Re: Engineering Services  
Loker Residence  
200 Castlebay Drive, Sanford NC  
11.000 kW System

APPROVED  
Limited building only review  
Permit holder responsible for full compliance with the code

KENNETH LOKER  
RESIDENCE  
200 CASTLEBAY DR,  
SANFORD, NC 27332, USA  
PHONE NO. (808) 294-6446  
EMAIL ID: lokerkr@yahoo.com

SHEET NAME  
COVER PAGE

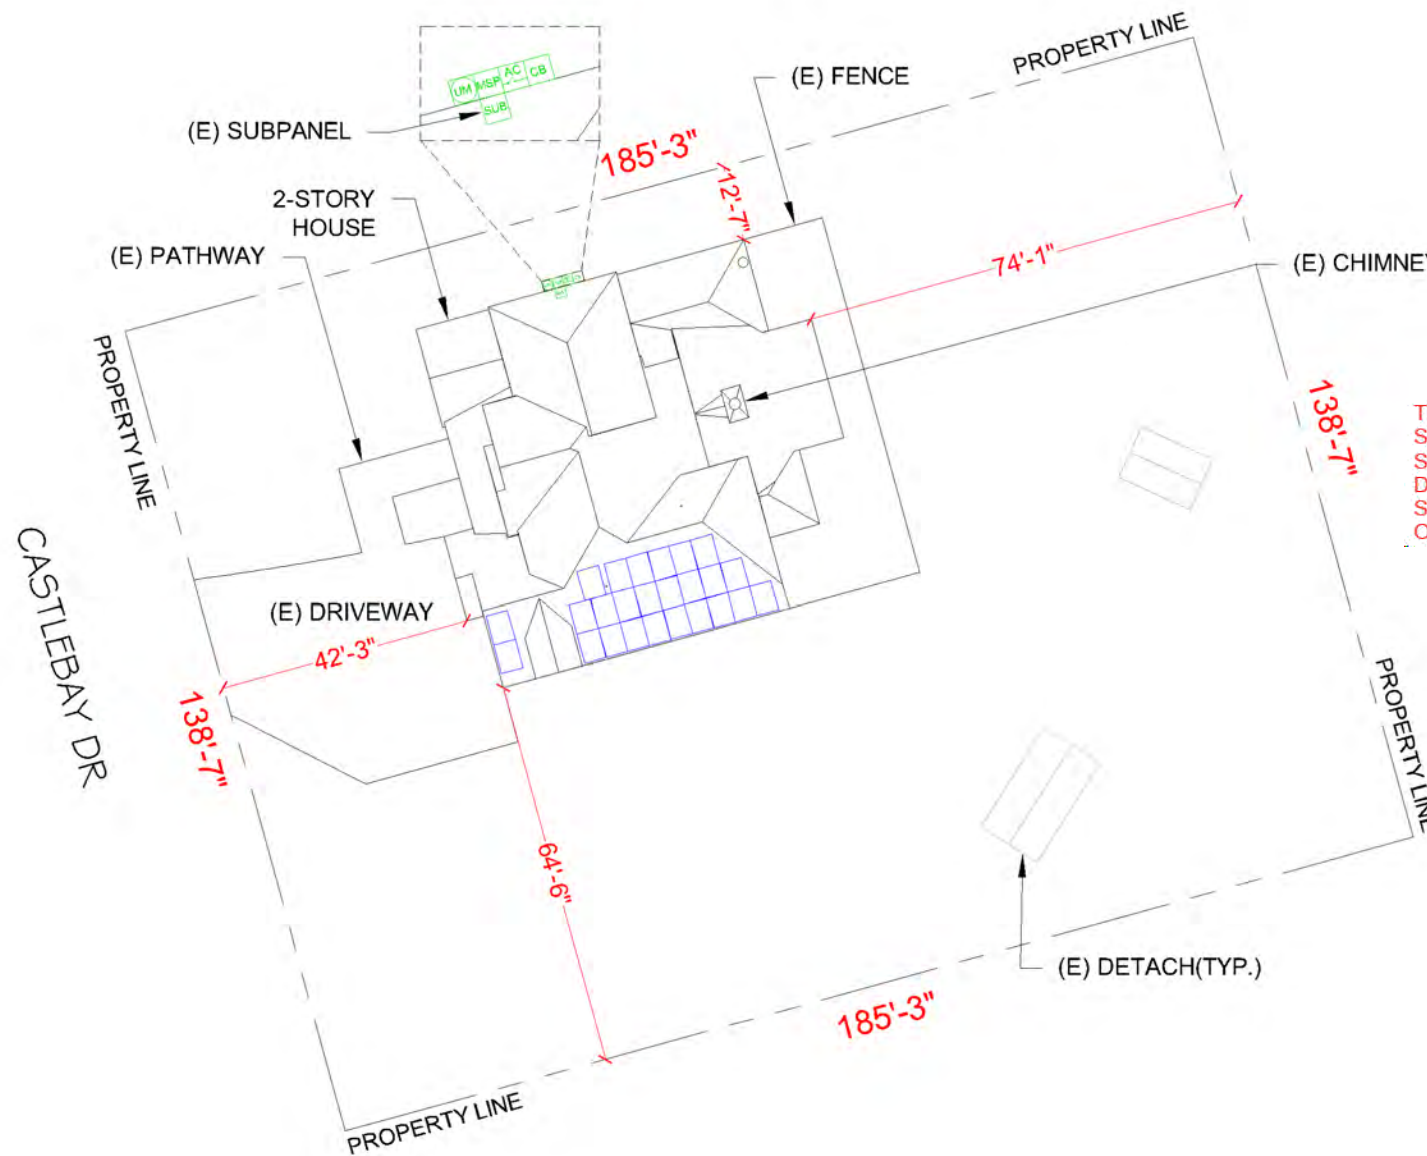
See note on single line

SHEET NAME  
**ELECTRICAL**  
**LINE & CALCS.**

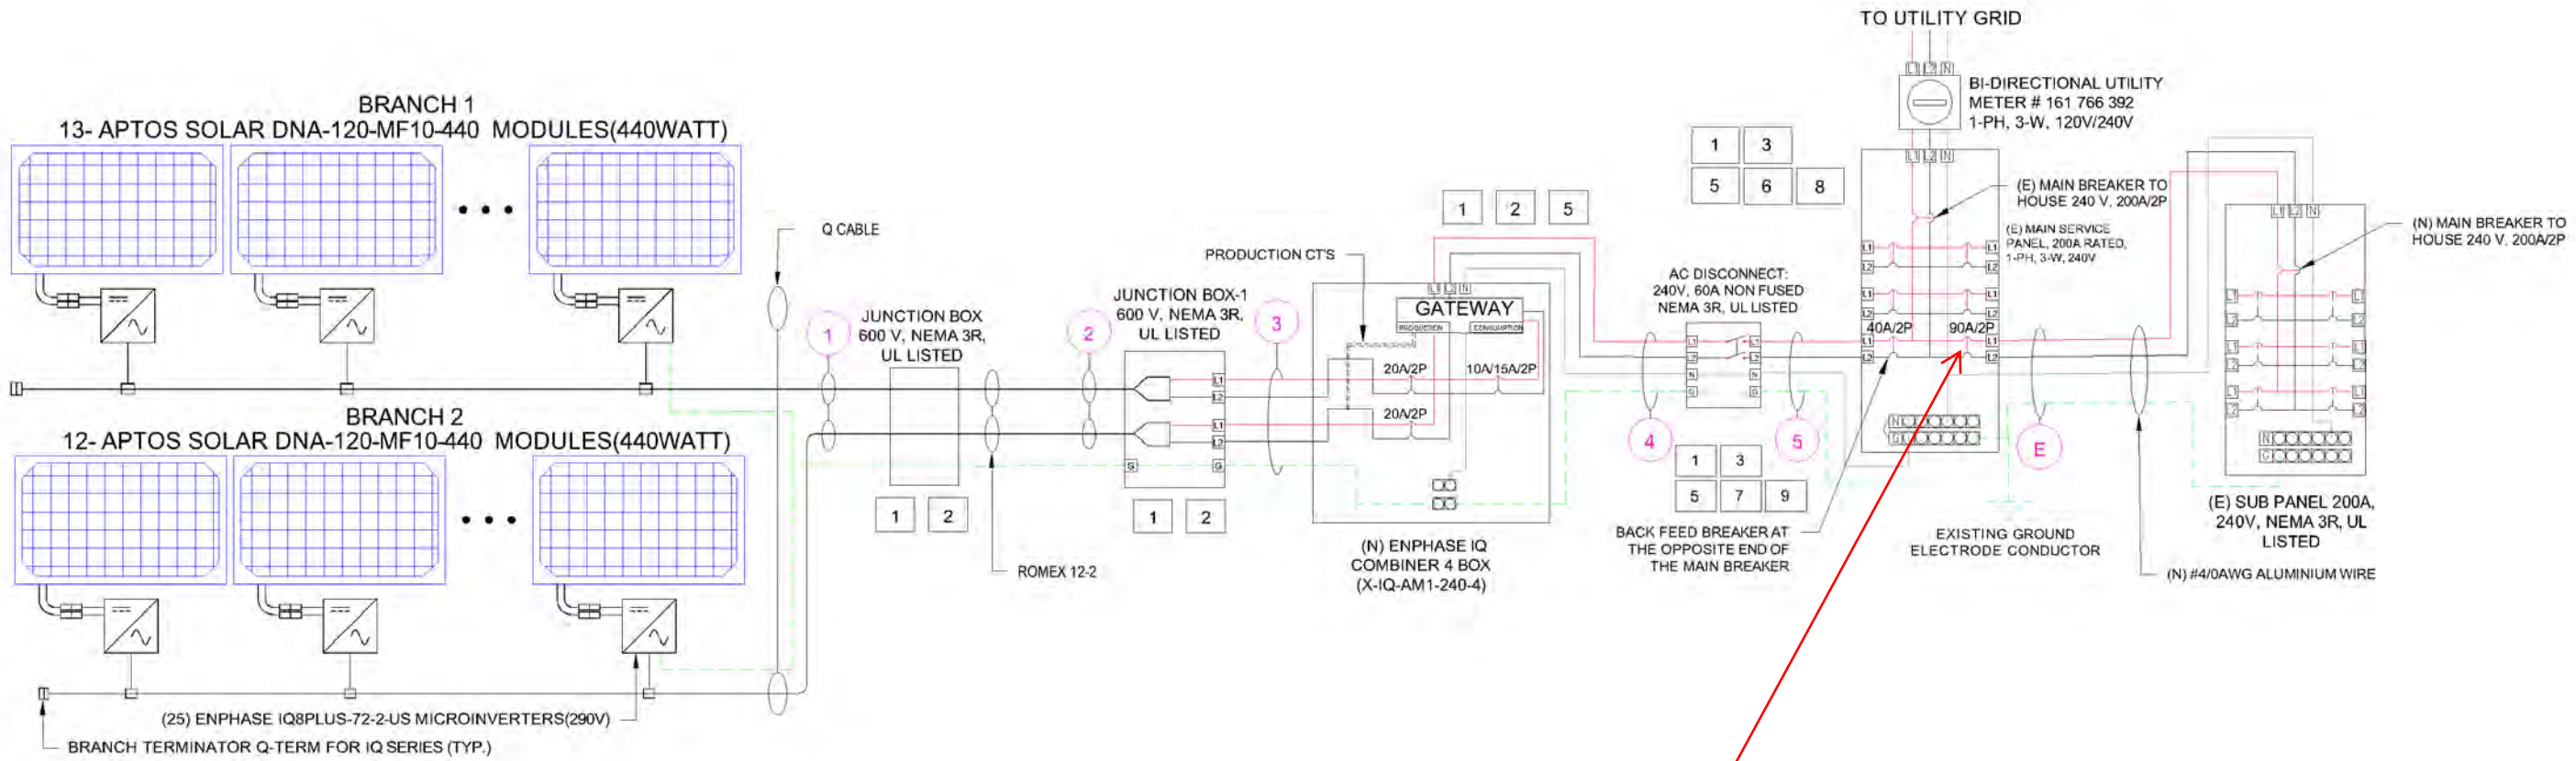
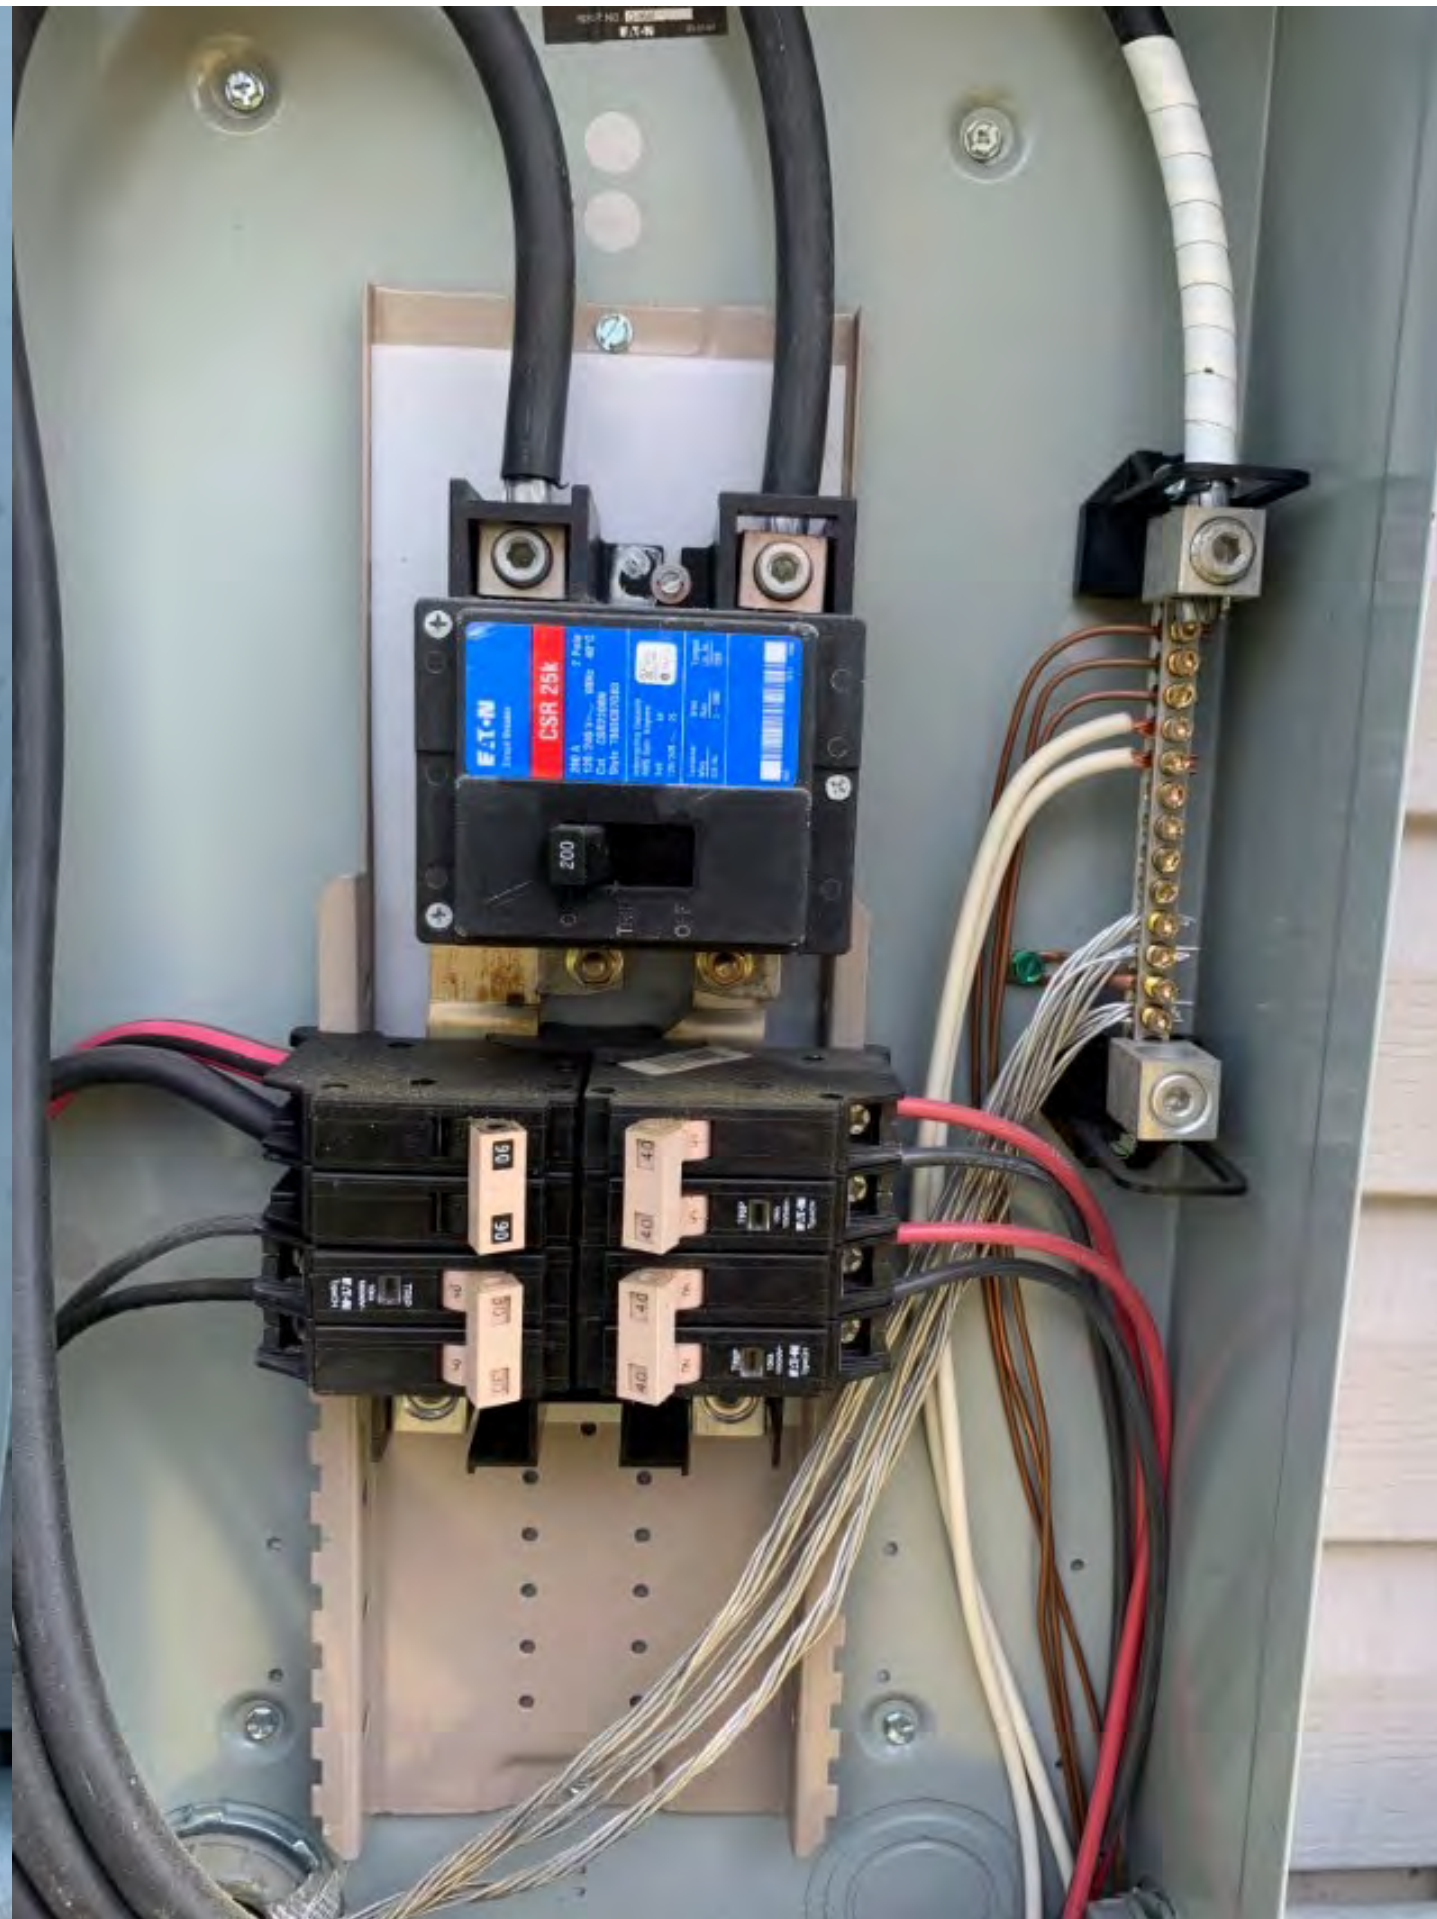
This must be a feed through. 4/0 will not fit into a 90A breaker
